AGENDA
OXFORD CITY COUNCIL REGULAR MEETING
COURTHOUSE

TUESDAY, OCTOBER 3, 2023 AT 7:30 PM

ORIGINATING DEPARTMENT:	Community Development
PREPARED BY:	Sam Perry
DATE PREPARED:	9/26/2023
COUNCIL MEETING DATE:	October 3, 2023
AGENDA TITLE:	An Ordinance Approving A Conditional Use Permit Application To Allow For A New Hotel To Be Located At 525 North Campus Avenue, Oxford, Ohio 45056 With Conditions. (Sam Perry, Community Development Director)
COUNCIL GOAL AREA:	Economic Development
BUDGETED AMOUNT:	
ACCOUNT CODE:	
RECOMMENDATION:	Accept Planning Commission recommendation for approval with conditions
CITY MANAGER/DEPT HEAD APPROVAL:	SP DRE

RE: Oxford Hotel, Marriott Fairfield
Planning commission meeting 9/12/2023
July 27, 2023 correspondence
22-0261 CD – BINDER 230907
22-0261 AT Firetruck
Architectural A211, A212

SITE PLAN

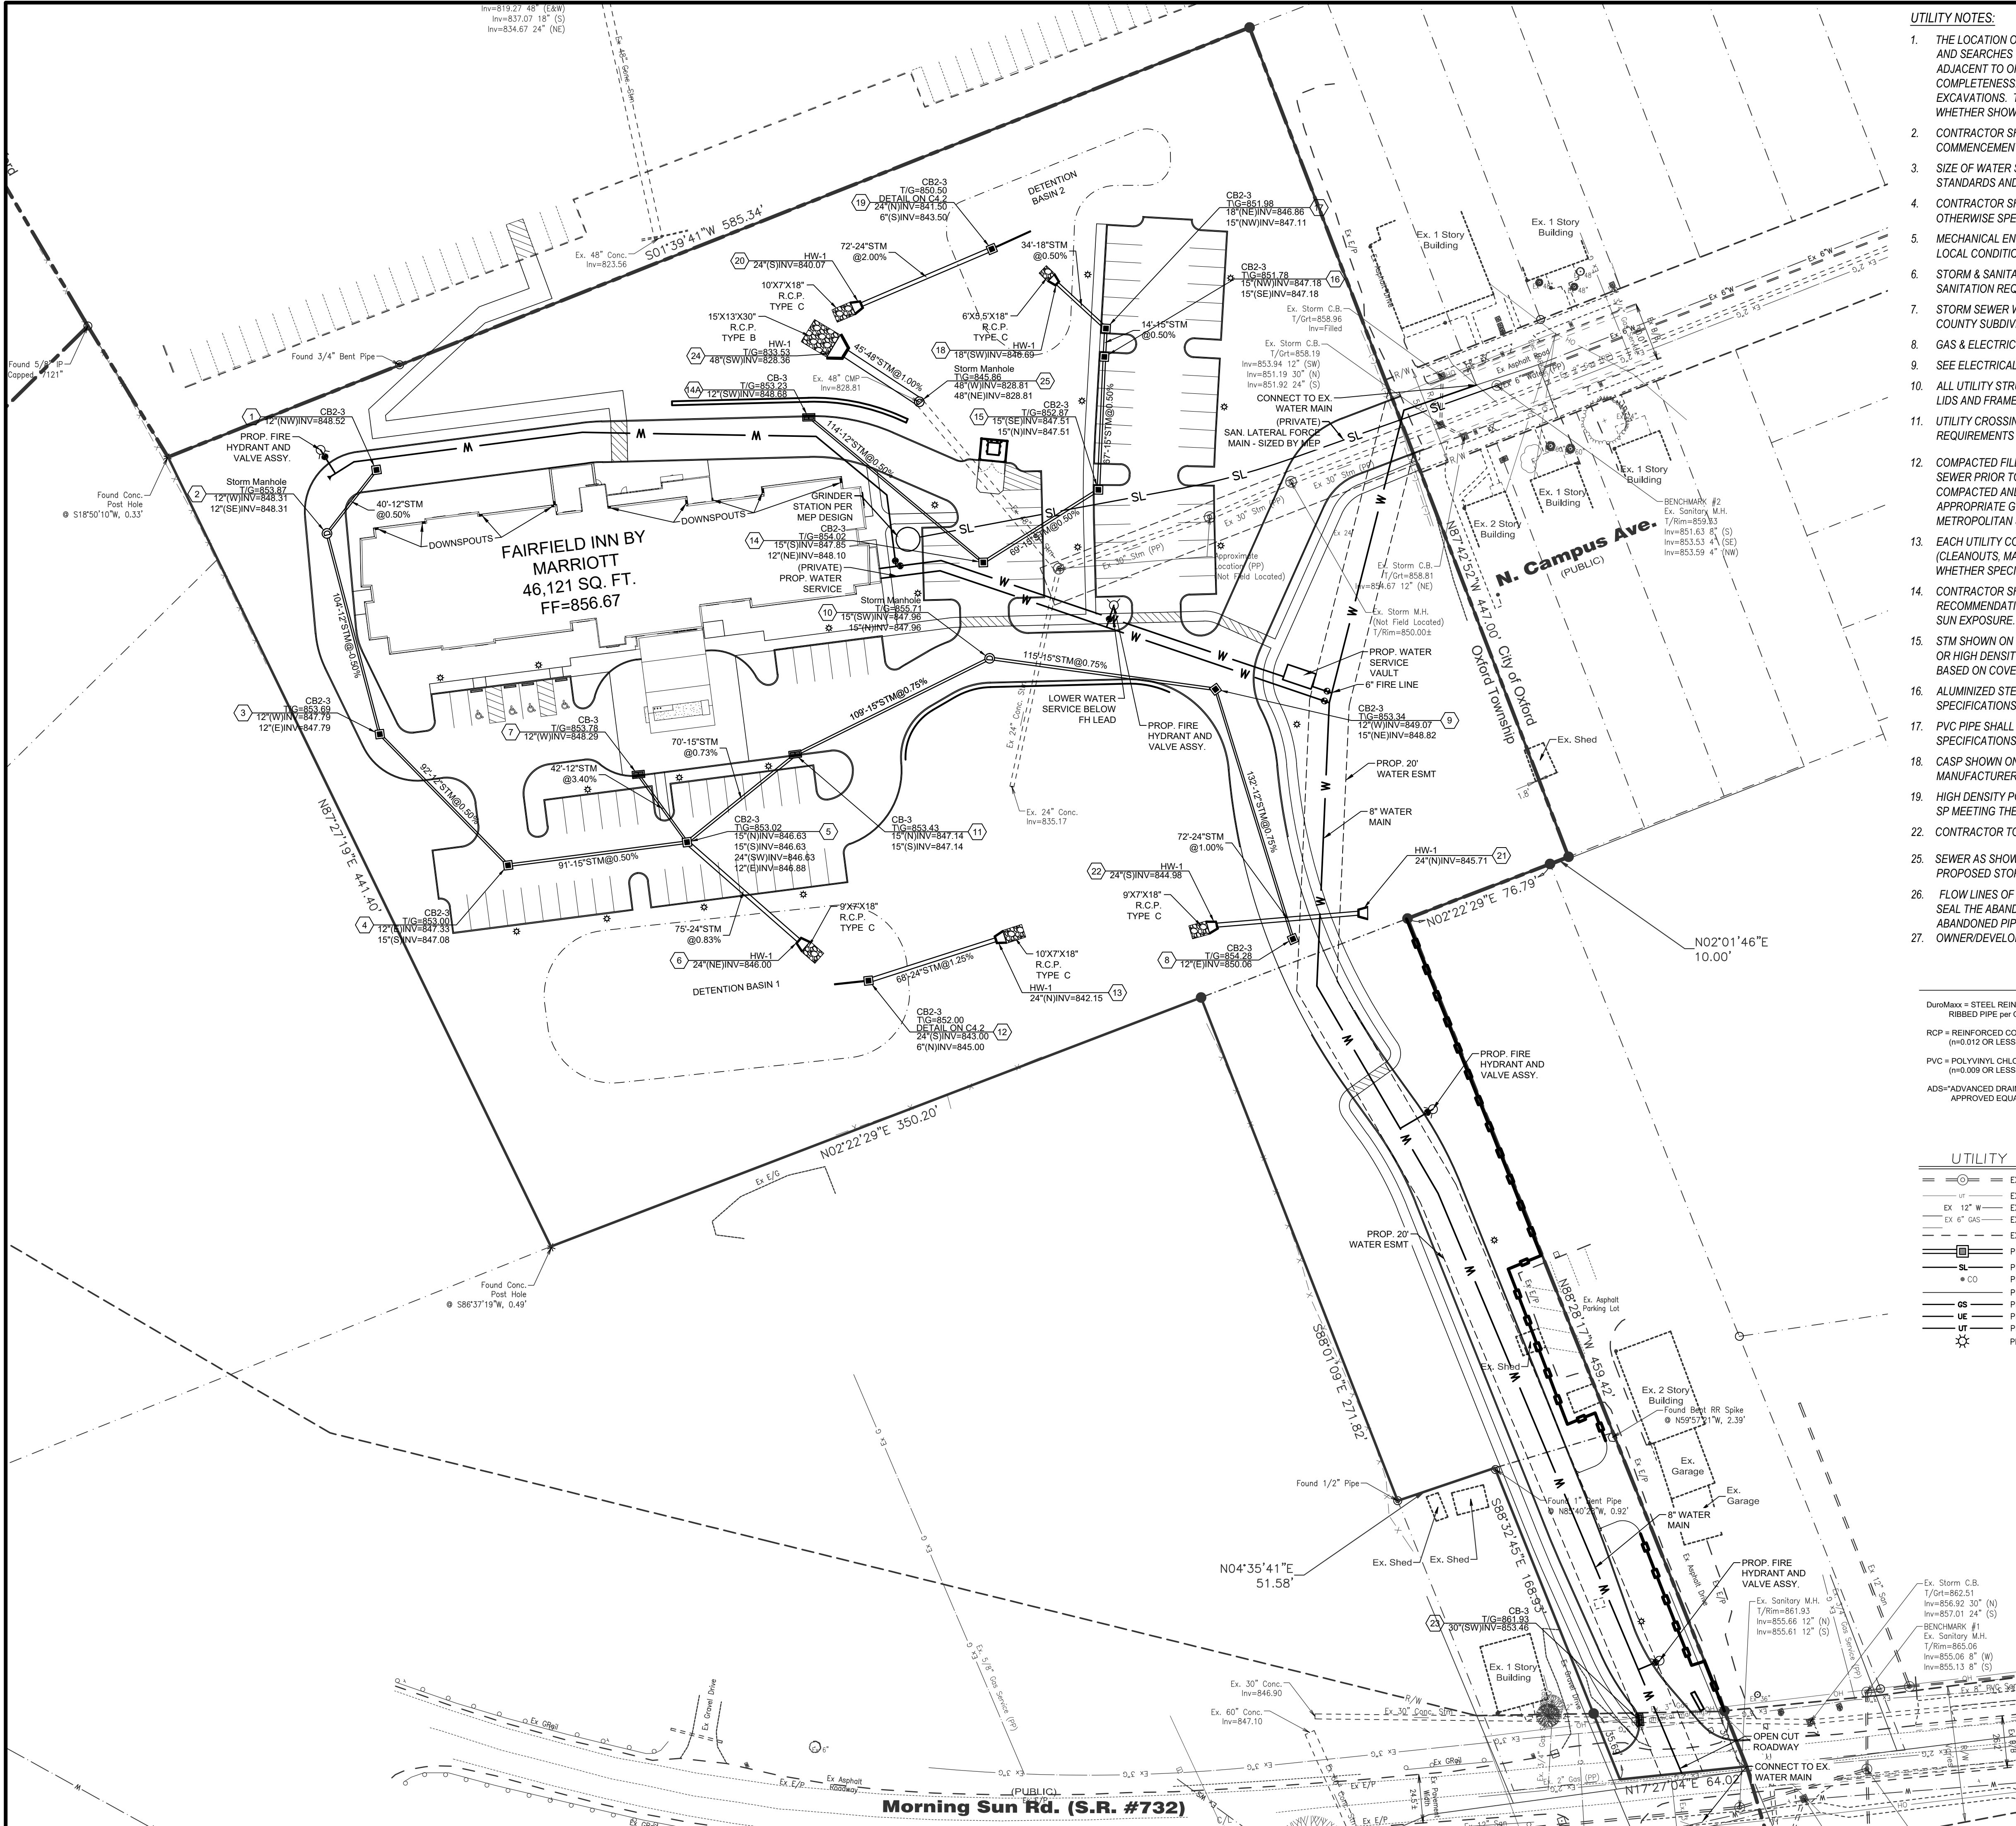
13. **Section 1149.07(e)(4)(E)** specifies that *all unpaved areas adjacent to an off-street parking area shall be raised, landscaped, and separated from the parking area by a minimum 6-inch high concrete curb*. Examining Sheet C3.0, it appears that not all proposed vehicular drive surfaces have curbing around the outside edges. Occasional openings are permitted for stormwater management purposes, but entire stretches of drive/parking cannot lack curbing.

18. **Section 1151.03(e)(1)** provides that *no freestanding sign shall be closer to a lot line or the public right-of-way than the height of the sign [...]*. Per Sheet C3.0, a monument sign is proposed to be situated partially within the right-of-way along Morning Sun Road, thus not conforming to this standard despite what the planned height might be.

- As can be seen on updated civil drawings attached, we have increased the setback distance to 25' on all sides of the property including the northern edge per recommendation. We have also included the access road on the north side of the building. This has resulted in the building being further to the south. Reference C 3.0 drawing

- Building orientation: The Building orientation was the outcome of a discussion with community neighbors, especially to the north property line. The orientation results in the building windows being more obscure to the neighbors. In additional conversations we have also added more landscape screening/ buffering and fencing to the north line in an east west direction. This has been reflected on the updated civil drawing package. Also, the lighting along the north side access road for the project is utilizing bollard lighting in lieu of pole lighting, thus reducing over spill of lighting. Reference C 3.0 drawing

- The Access Road for Fire access is depicted on the civil drawings. The turn radiuses and travel route is shown on Drawing C 3.022-0261 AT Firetruck. A retaining wall and grading of the Southeast corner area adjacent to the access road has been incorporated and is shown on drawing C 5.0 Grading.

- Signage for the Building is now shown only at the front entrance on Morning Side Road (ground monument sign Drawing C 3.0) and on the front elevation of the building only. Reference drawing A211 front elevation depicts the building facade sign. A small ground non illuminated sign at the Campus Avenue entrance for identification if possible is proposed but is not shown unless approved.

3 SIDE ELEVATION WEST
1/8" = 1'-0"

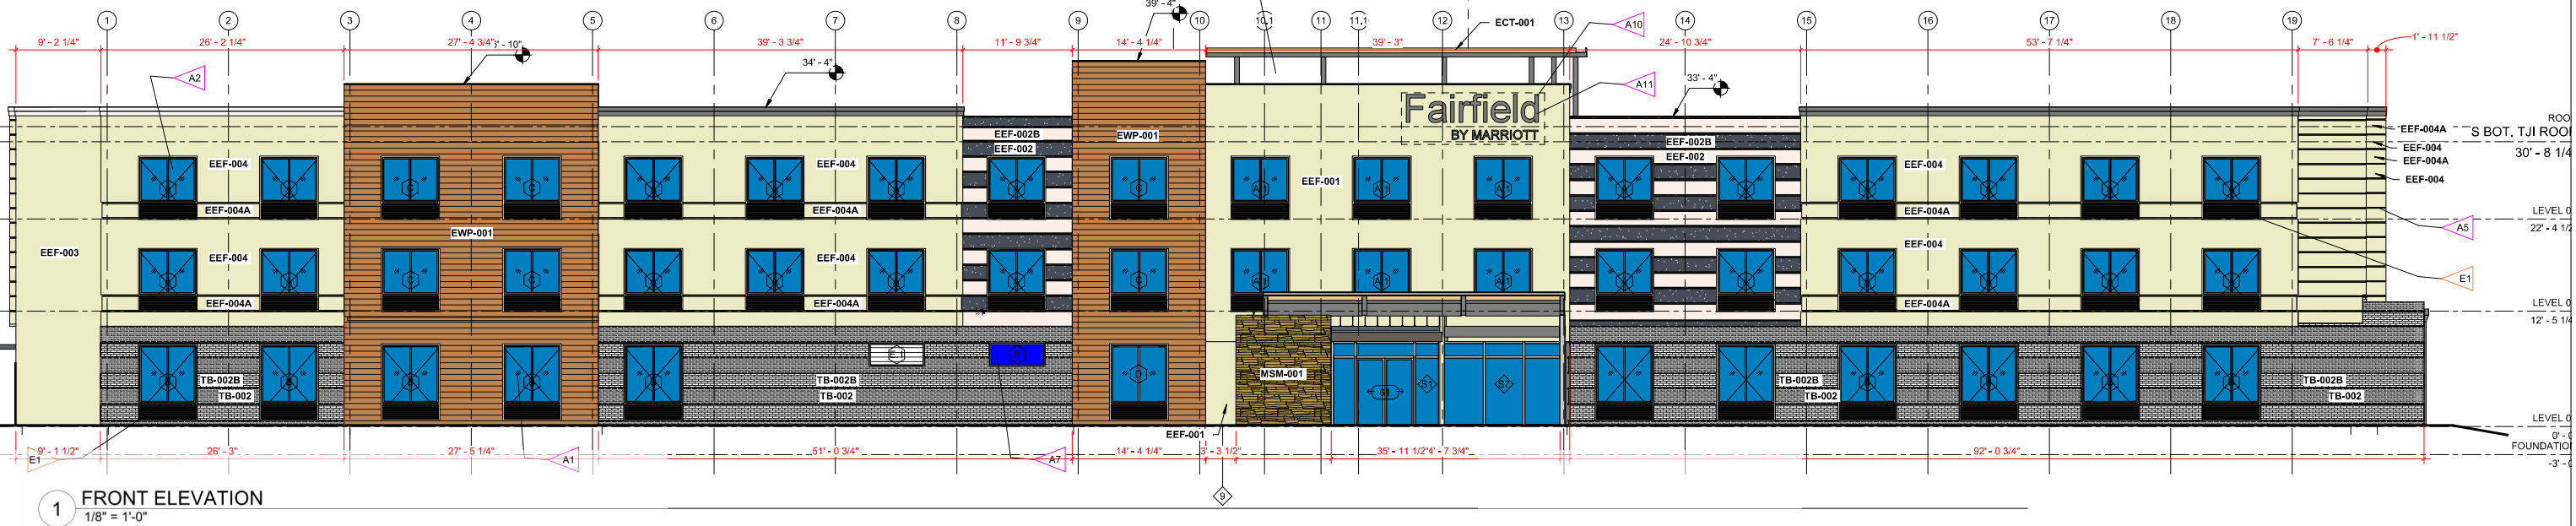
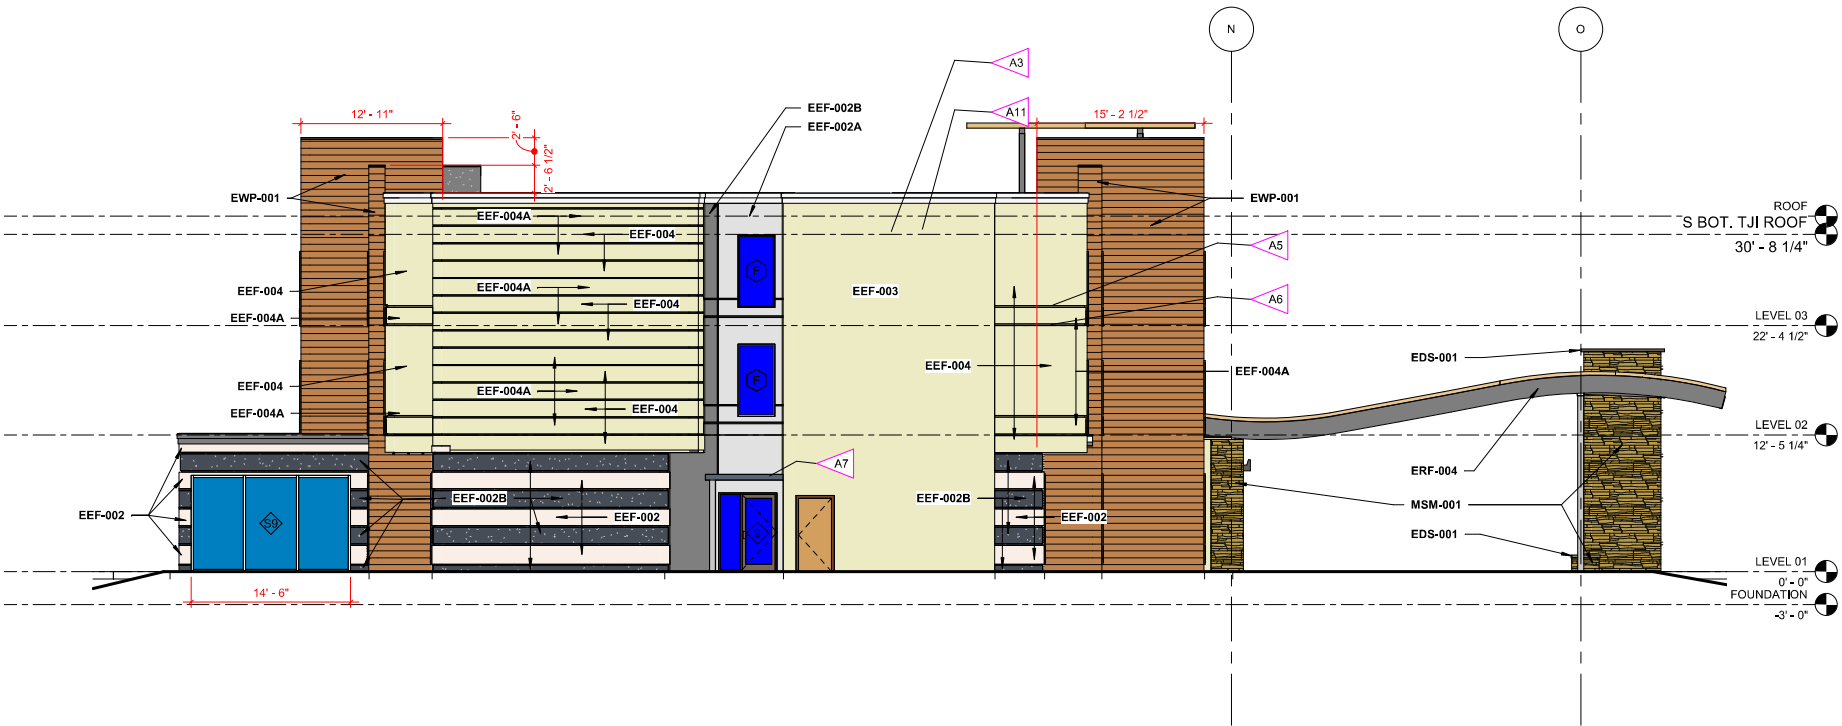
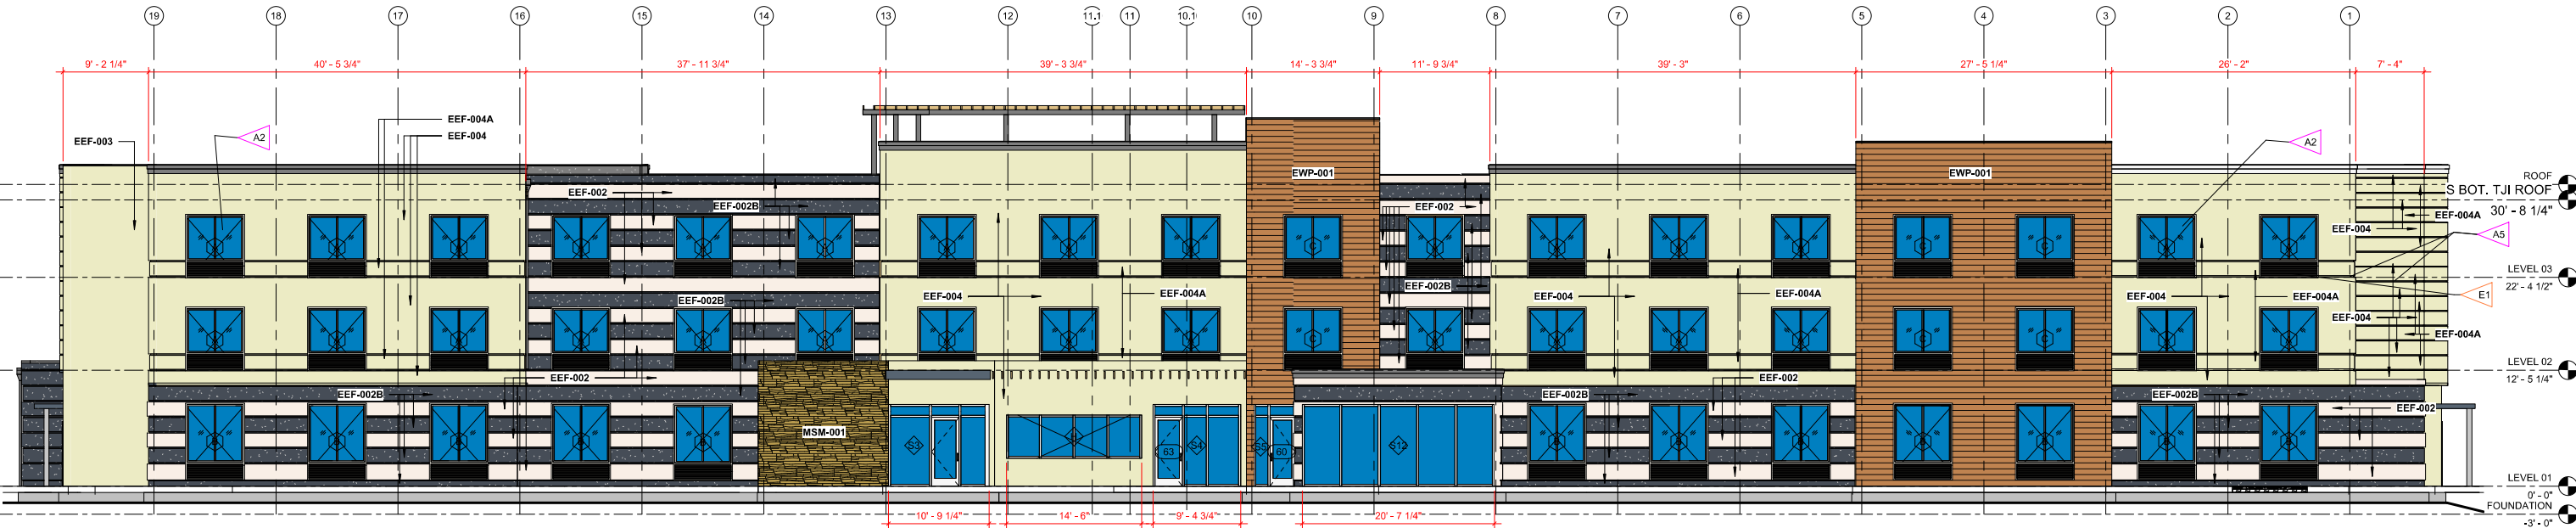
During the August hearing there were several questions raised by Commission members and the public about the location of the building, orientation of the building, architectural materials, storm water runoff, sound trespass, light trespass, vegetative screening, fire truck access, vehicular traffic, vehicular speed and identification signage. The following neighbors spoke at the hearing: Craig Erickson, Sue Cameron, Gina Corso and James Taylor. The Commission voted to table the case so that more information could be collected by staff and the applicant.

- Turn lane analysis will be forthcoming upon issuance of access point permit which is provided by ODOT.
- The exterior façade natural materials has been increased and quantity calculations provided on Drawing A211.

FRONT FACADE CALCULATIONS FOR CITY OF OXFORD:

THIN BRICK	1,335 SF
CEMENT FIBER PLANK	426 SF
STONE	123 SF
GLAZING	2,447 SF
EIFS (VARIOUS)	4,537 SF
TOTAL	4,331 SF
FRONT FACADE	8,868 SF
